Office Action Summary	Application No. 10/067,812	Applicant(s) IWASAKI ET AL.	
	Examiner Julian Mercado	Art Unit 1745

Claims 1, 3-6, 10 and 11 rejected under 35 U.S.C. 102(b) as being anticipated by Abens et al. (U.S. Pat. 4,585,708).

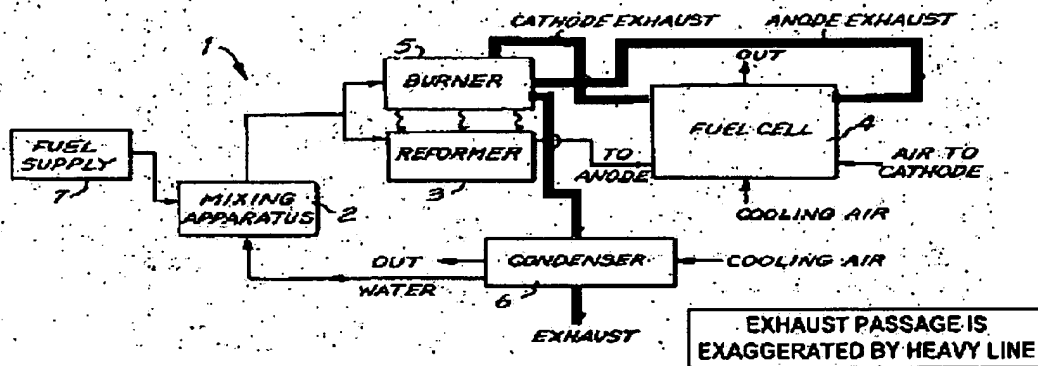
The rejection is maintained for the detailed reasons of record. The examiner notes that the claims have not been amended; the scope of the present claims are the same as that considered in the prior Office action. Applicant's arguments filed with the request for reconsideration have been fully considered, however they are not found persuasive.

USPQ2d 1429, 1431-32 (Fed. Cir. 1997) Indeed, the fuel cell system of Abens et al. comprises an exhaust gas circulation passage, as shown in Figure 1 submitted by applicant as follows:

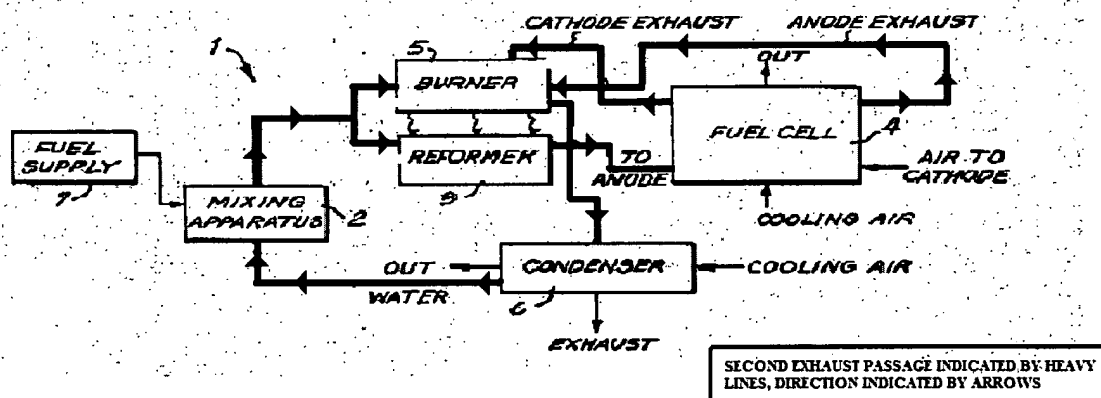
Applicant submits that Abens et al. does not disclose or suggest that part of the exhaust gas is circulated from the fuel cell back to the fuel cell. In reply, applicant is reminded that while features of an apparatus may be recited either structurally or functionally, claims directed to an apparatus must be distinguished from the prior art in terms of structure rather than function. *In re Schreiber*, 128 F.3d 1473, 1477-78, 44

Applicant submits that in Abens et al. the fuel cell system exhausts the cathode and anode exhaust gases outside of the fuel cell via the burner 5 and condenser 6, as shown by the heavy lines. While the examiner concedes with this interpretation of Abens et al., it is noted that the exhaust line also bifurcates from condenser 6 as follows:

Notwithstanding the functional language of the claim, it is asserted that Abens et al. teaches circulation of part of the exhaust gas, i.e. water, which is then mixed with the fuel

supply 7 at mixing apparatus 2, which is then directed to the reformer 3 wherein “[t]he reformer 3, in turn, converts the fuel-water mixture to fuel process gas which is delivered to the anode of the fuel cell 4.” See col. 2 line 52 et seq. Thus, it is asserted that part of the exhaust gas (which contains both exhaust gas and water) is circulated back to the fuel cell insofar as the water portion of the exhaust is used in the reforming reaction.

With respect to the reformer 3 not being in the exhaust gas circulation passage, as shown above by the second route of the exhaust line it is asserted that the reformer is indeed along the exhaust gas circulation passage.
